Re: Cherokee Nation WW Hastings Replacement Hospital - Addendum 02 Narrative

Following is a list of revisions included in Addendum 02.

PROJECT PHASE:
BID PACKAGE 02
(SITE DEMOLITION AND UTILITIES)

SHEET NUMBER:
C7-212

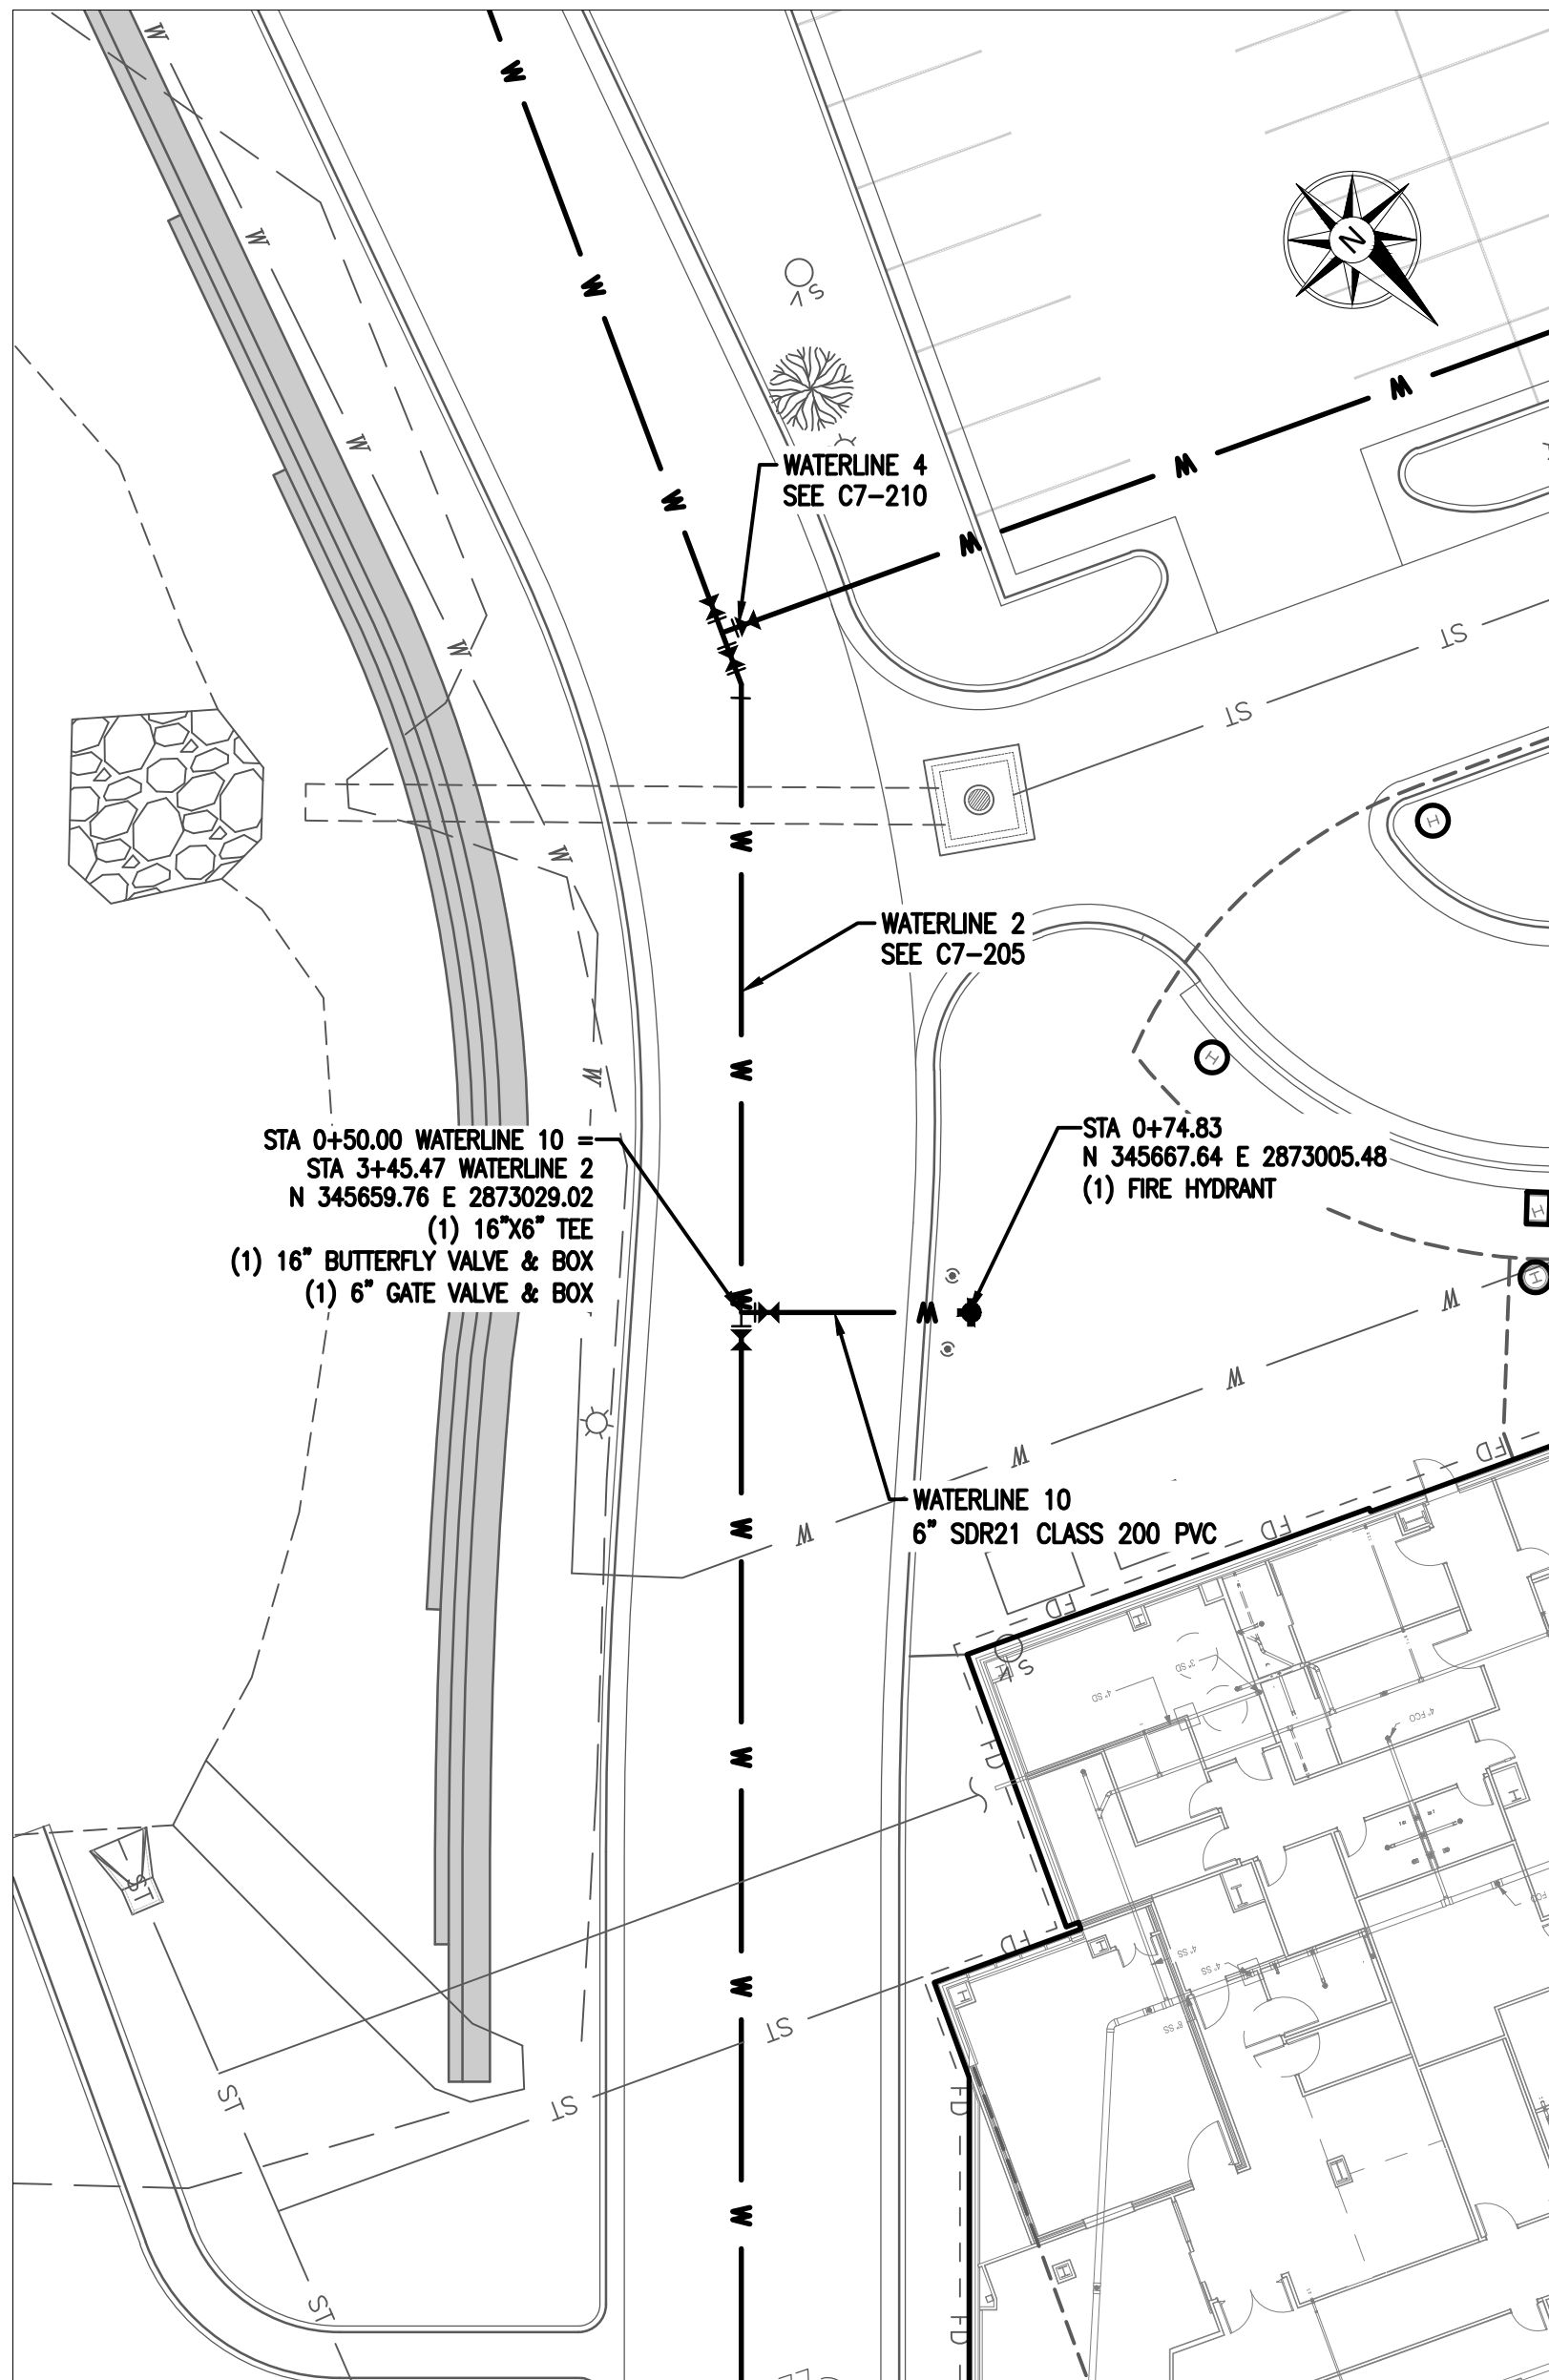
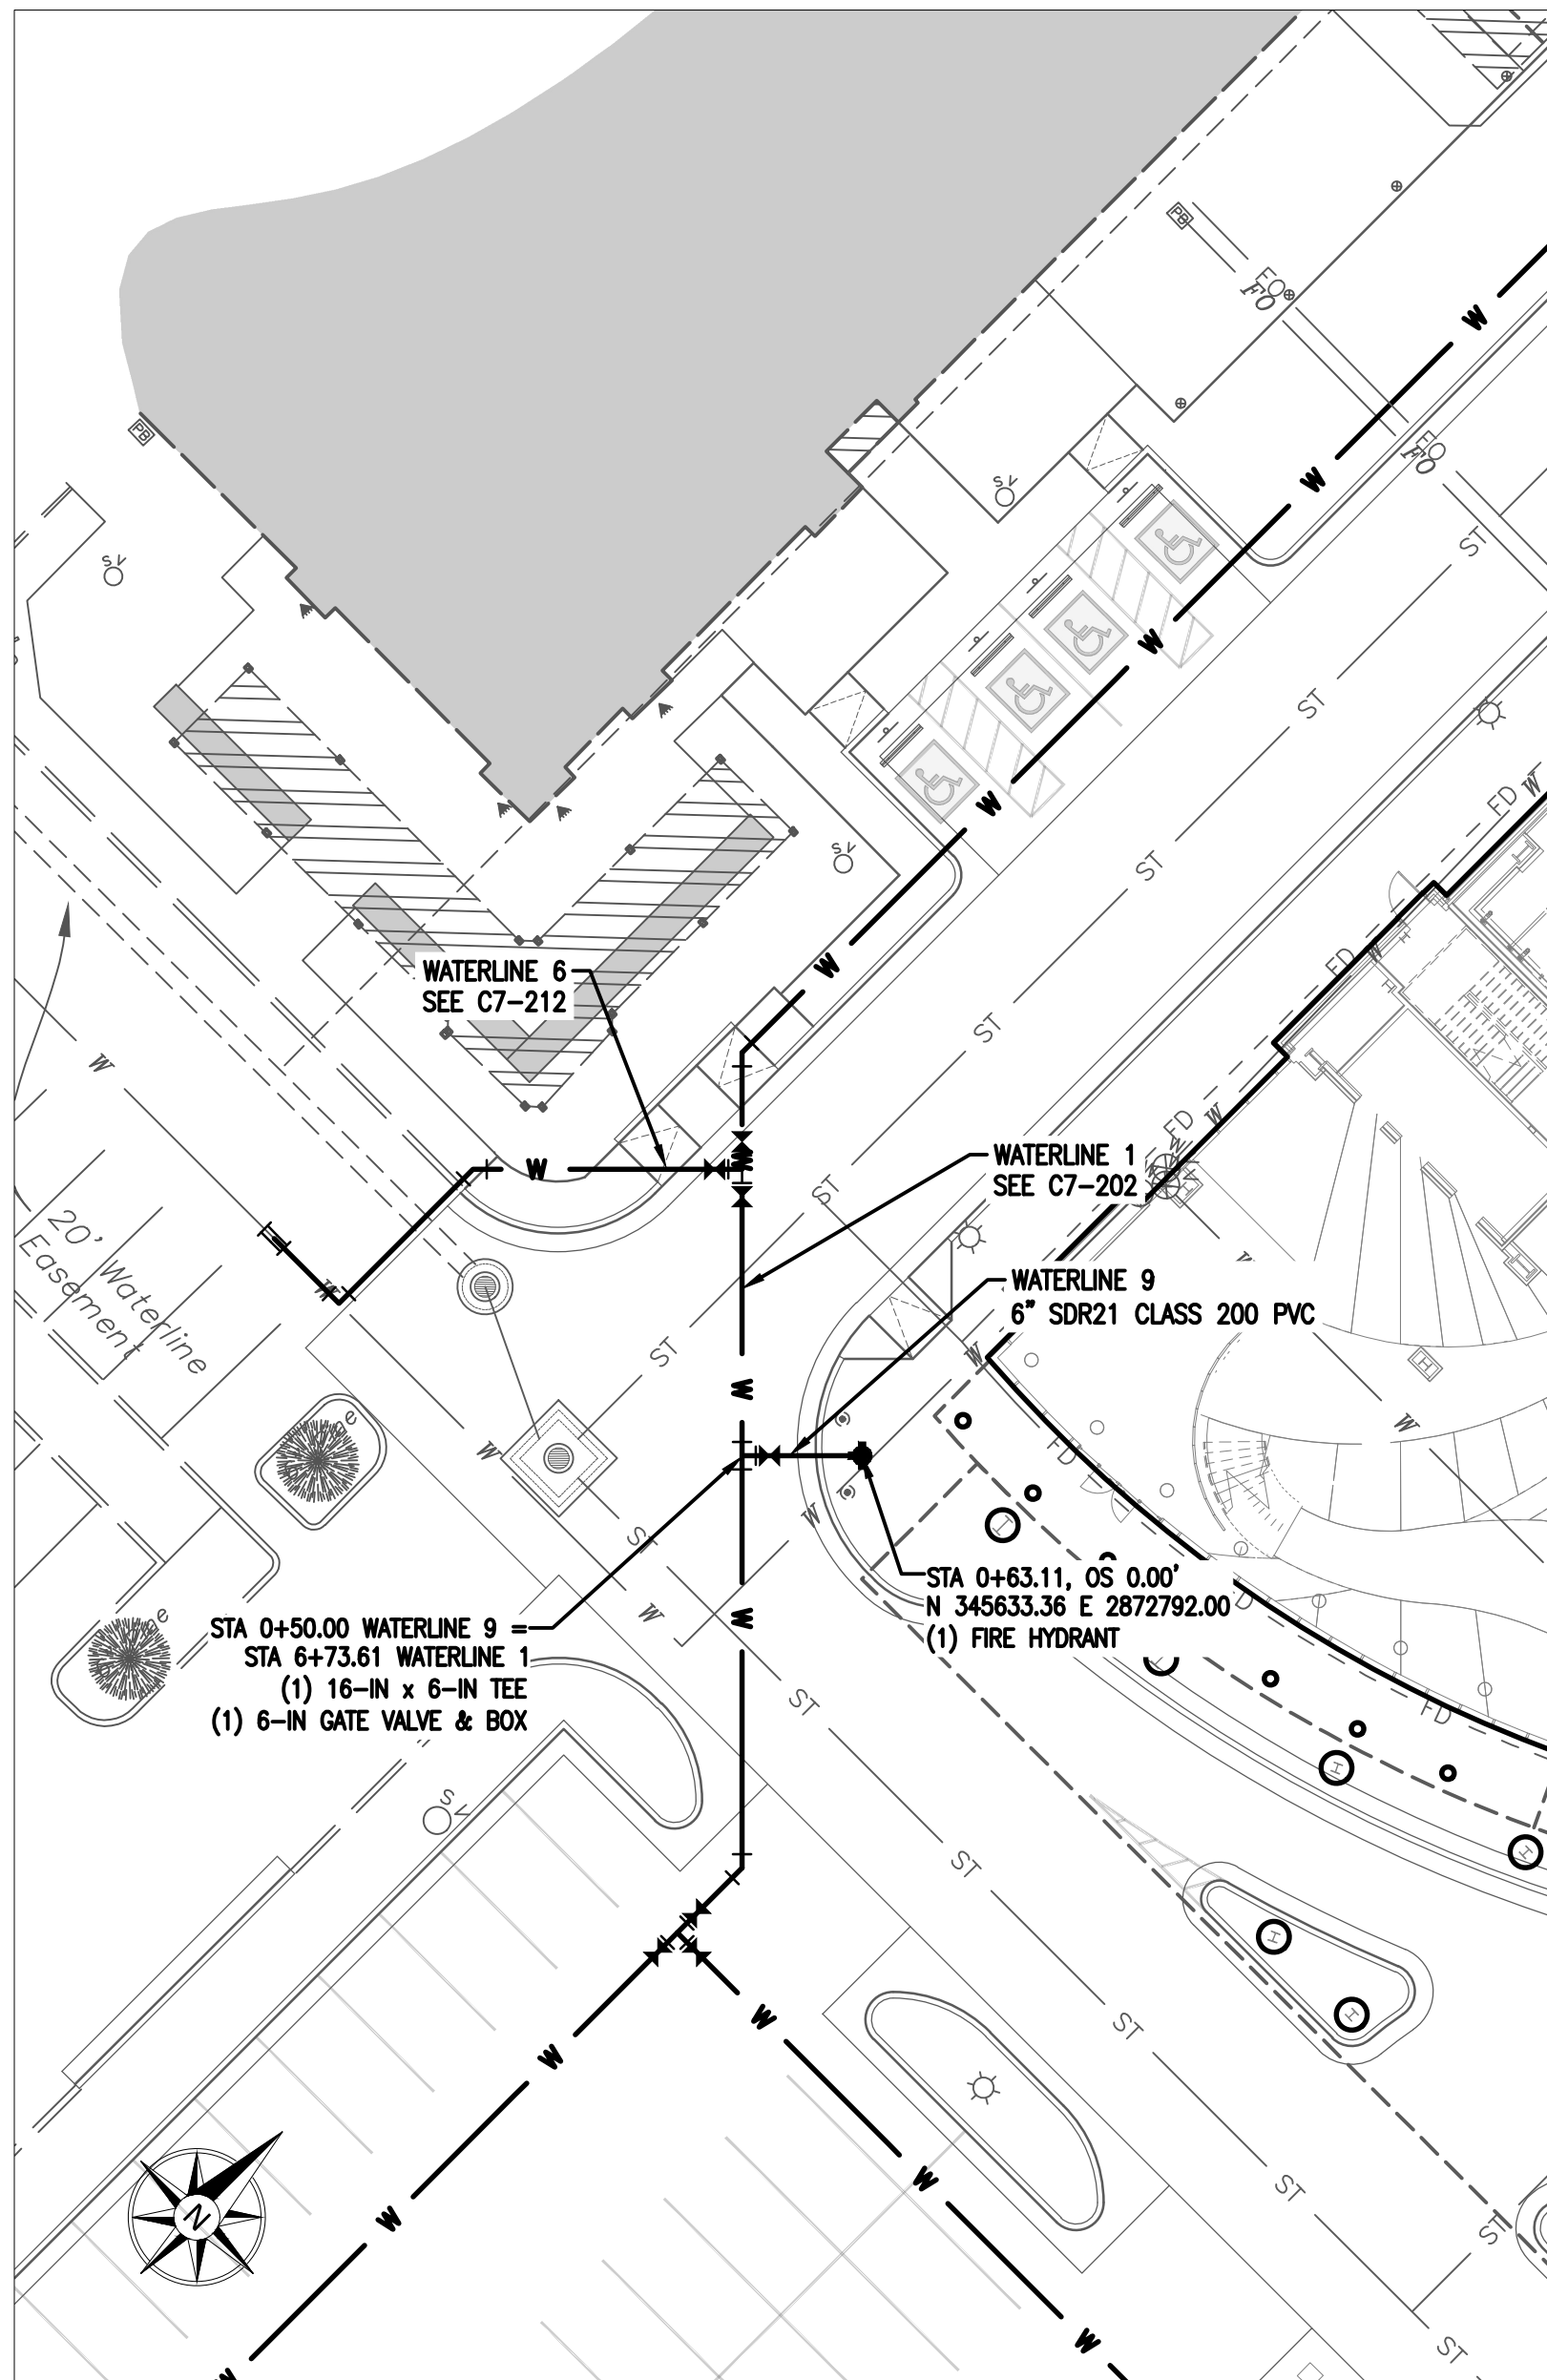
- C7-212 - Added the graphical presentation of the gate valve and fire hydrant to the profile view.
- C7-213 - Added call-outs to the materials in the plan view of Water 8.
Revised the profile view of Water 8 to match the plan.
Added labels to the plan view of Water 13.
